FORM APPROVED
OMB NO. 1004-0135
Expires: July 31, 2010**SUNDRY NOTICES AND REPORTS ON WELLS**
Do not use this form for proposals to drill or to re-enter an abandoned well. Use form 3160-3 (APD) for such proposals.

5. Lease Serial No. NMNM67980
6. If Indian, Allottee or Tribe Name
7. If Unit or CA/Agreement, Name and/or No.
8. Well Name and No. SANTA FE FEDERAL 7
9. API Well No. 30-015-27118
10. Field and Pool, or Exploratory DELAWARE
11. County or Parish, and State EDDY COUNTY COUNTY, NM

Santa Fe Fed #7 Plug and Abandon Procedure

**Santa Fe Federal 7
Proposed WBD**

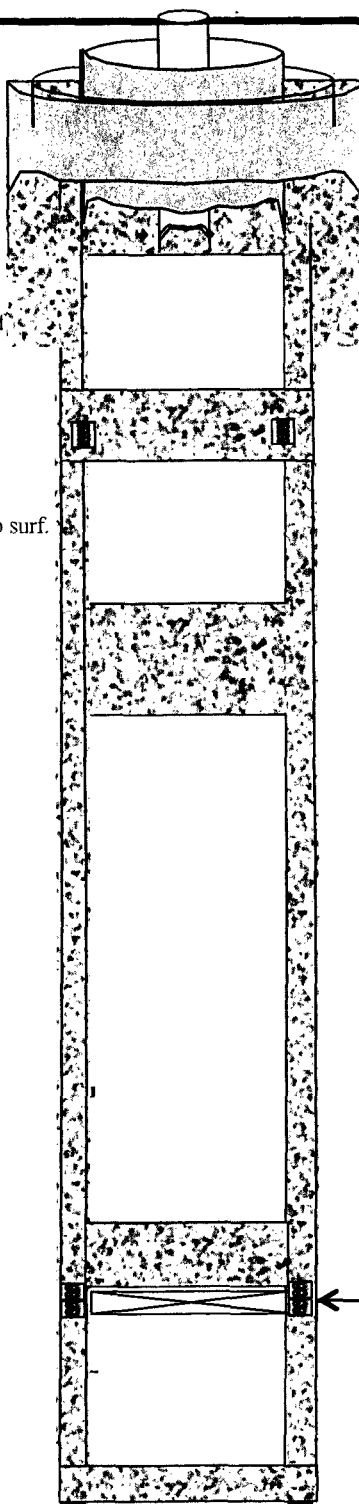
- 7) WOC & Tag *Add Plug (DVT) 5075 - 4925 100c Tag*
- 8) PU & LD tbg. to 2850' - Spot 45 sxs from 2950' - 2550'.
- 9) PU & WOC - Tag cmt. - **Max tag 2550.**

- 12) WOC & Tag @ 1175'
- 13) *1355*
If good cement bond and unable to squeeze - Spot 40 sxs from ~~1305'~~ to 905' ~~If tagged cmt. @ 1175' spot 25 sxs~~
~~cmt. from 150' to surface.~~ *Spot cmt from 461' - 361' woc Tag*

- 14) RDMO Service Unit. RDMO Cementers. *Spot cmt from 150 - Surf.*
- 15) MIRU Welder. Cut-off casing head. WO cap with well name and number, operator name, and date.
